DEVELOPMENT REVIEW BOARD
SUPPLEMENTAL SUBMITTAL

PROJECT NO. PR 2018-002559
Application No. SD 2019-00055

DRB Project Number: 2019-002559
University Heights Addition

PLAT OF
LOTS 1-A-1 & 1-A-2, BLOCK 10
UNIVERSITY HEIGHTS ADDITION

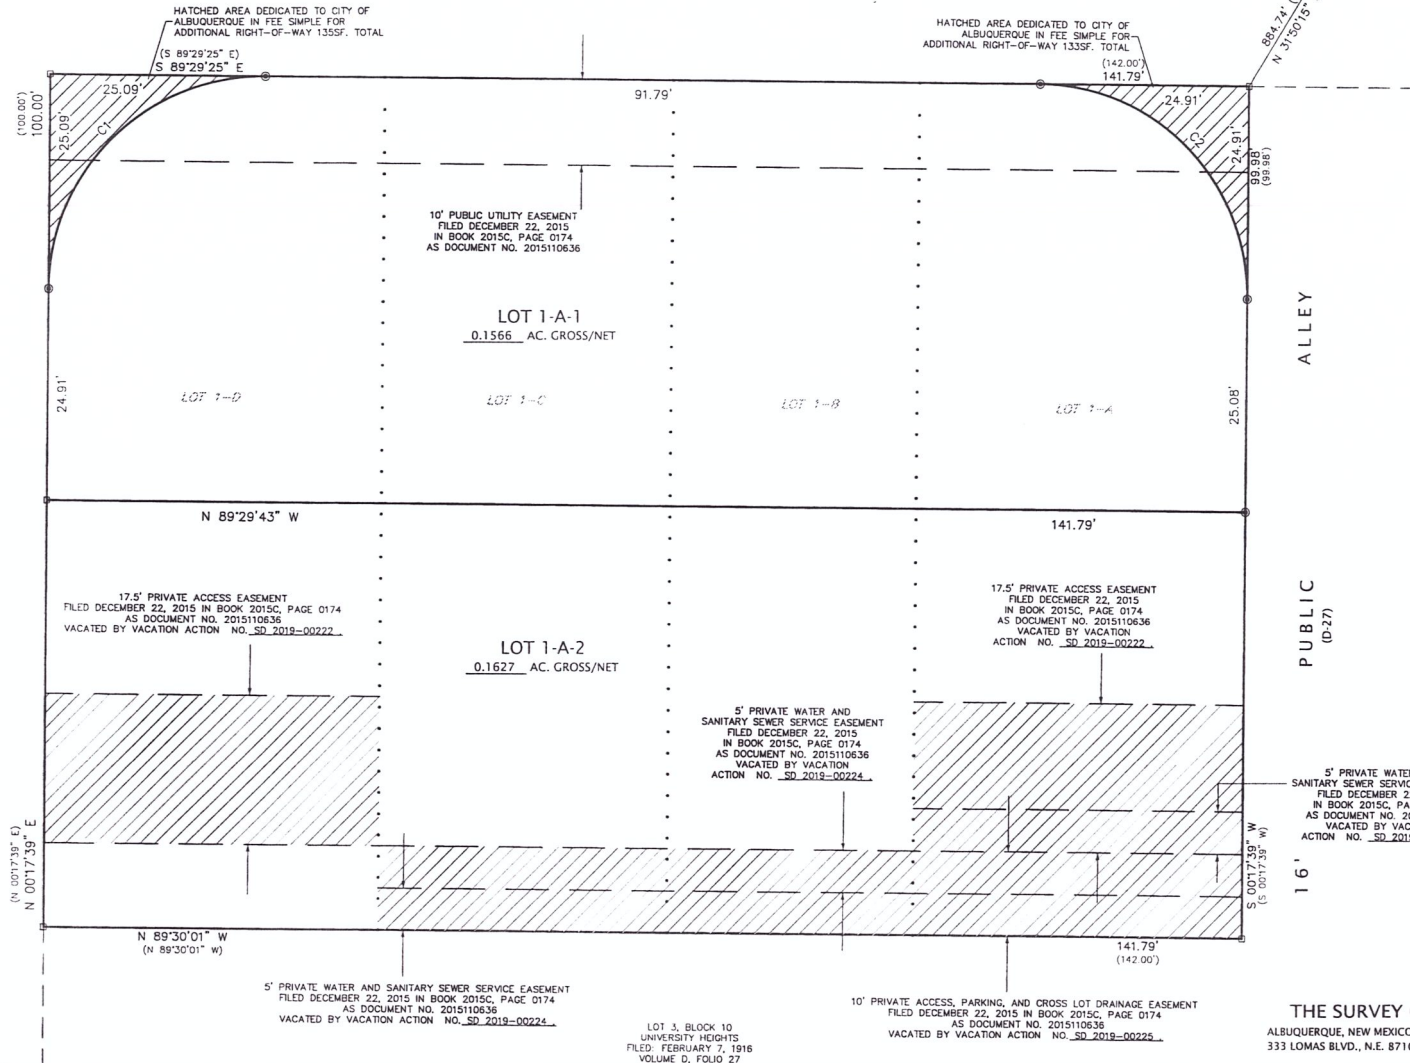
1. Transportation Department has no objection to the vacation of the easements.
2. Right of Way dedication is required to add a curve to the northwest and northeast corners of the property abutting Silver Avenue. (Sight distance is of special concern at Silver/Cornell based on pavement markings for yielding and crosswalks.) Refer to DPM Table 23.3.3 for requirements.
3. Infrastructure list is required to widen alley, and the current standard for alleyway right-of-way is 20 feet. Right-of-way dedication is required.
4. If future development is not going to be submitted to DRB, a TCL (Traffic Circulation Layout) will be required before building permit.

SUBMITTAL DESCRIPTION: UPDATED PLAT REFLECTING CURVES ADDED TO NORTHWEST

AND NORTHEAST CORNER OF PROPERTY AS PER DPM REQUIREMENTS.

1. **Transportation Department has no objection to the vacation of easements.**
2. Right of Way dedication is required to add a curve to the northwest and northeast corners of the property abutting Silver Avenue. (Sight distance is of special concern at Silver/Cornell based on pavement markings for yielding and crosswalks.) Refer to DPM Table 23.3.3 for requirements
RESPONSE: Updated plat reflects curves added to the northwest and northeast corners as per DPM requirements.
3. Infrastructure list is required to widen alley, and the current standard for alley way right-of-way is 20 feet. Right-of-way dedication is required.
RESPONSE: Request for waiver provided.
4. If future development is not going to be submitted to DRB, a TCL (Traffic Circulation Layout) will be required before building permit.
